Technical Bulletin

The Worlds smallest Push Button - PB 100 Just got better!

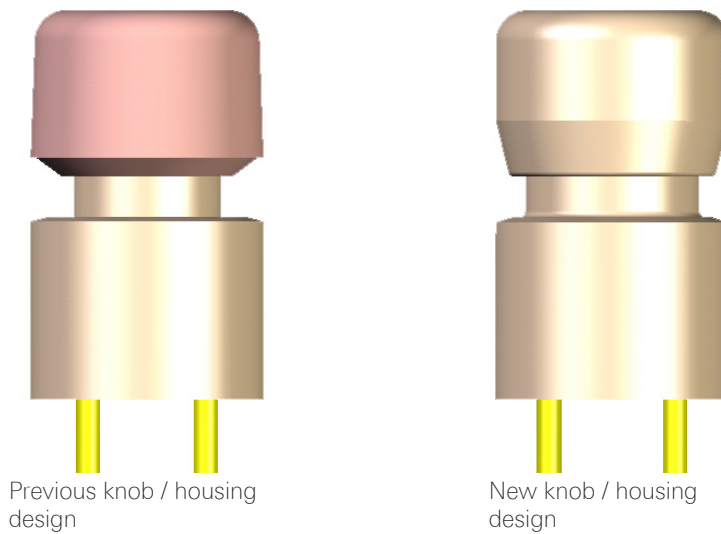
Therefore, we are pleased to announce that we have achieved a more robust component by reducing the 'fingernail catch' between the Housing and the Knob on our PB 100 Switch. This is achieved by a slight re-design of the Knob and Housing.

This optimization of the design has minimized a potential risk of pulling out the Knob from the Housing by a fingernail.

The visual appearance (form) has been changed slightly, however it will not have any overall affect on the fit and function of the PB 100. Consequently, this change will have no influence on the part numbers that you order today. The improvement will be implemented in week 07, 2006. The change can be easily identified by the visual appearance of the knob itself, as shown earlier in this document.
